ACCESSION NBR: 8202080374 DOC. DATE: 82/01/28 NOTARIZED: NO DOCKET #
 FACIL: 50-397 WPPSS Nuclear Project, Unit 2, Washington Public Power 05000397
 AUTH. NAME AUTHOR AFFILIATION
 BOUCHEY, G.D. Washington Public Power Supply System
 RECIP. NAME RECIPIENT AFFILIATION
 SCHWENCER, A. Licensing Branch 2

SUBJECT: Forwards marked-up response to Containment Sys Branch Issue 47a-f, "Acceptable SRV Design Load Spec" from 810914-17 meeting. Revised Page 5 to response to Issue 48, submitted 820113, encl.

Subject: NUCLEAR PROJECT NO. 2
RESPONSE TO CSB ISSUES 47 & 48

ISSUE 47Acceptable SRV Design Load Specification

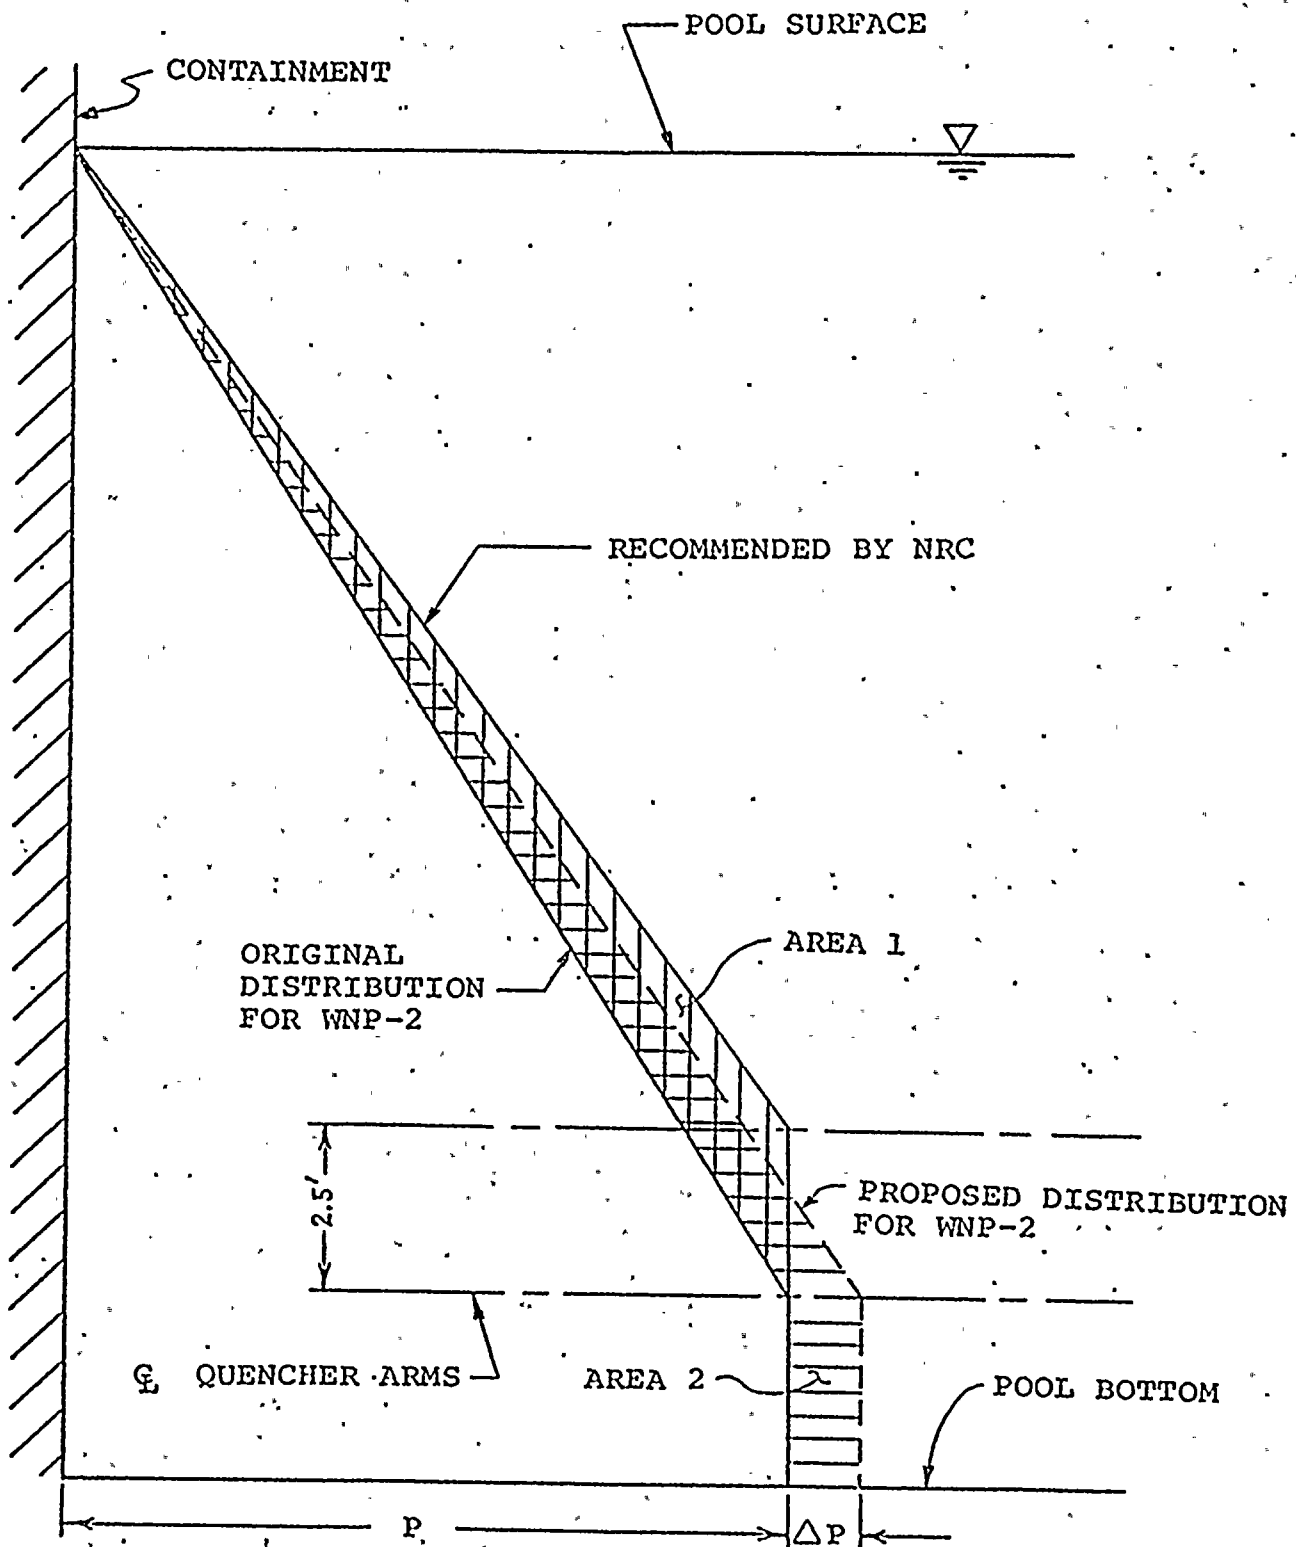
- e.
 - 1) For multiple valve case at initial actuation, the vertical pressure distribution used as specified in the WNP-2 SRV report is acceptable.
 - 2) For single valve case, at subsequent actuation, the staff requires the method of NUREG-0487 for vertical pressure distribution or provide justification that the present load design is conservative.

Notwithstanding all the above, the Supply System agrees as a measure of added conservatism to adopt the excessively conservative vertical pressure distribution recommended by NRC in a manner compatible with presently implemented analyses, as illustrated in attached Fig. I. This ensures that the total pressure-load applied to the suppression pool vertical boundaries is preserved and requires an increase by 10.7% in boundary pressure.

FOR AREA 1 = AREA 2, $\Delta P = 10.7\% (P)$
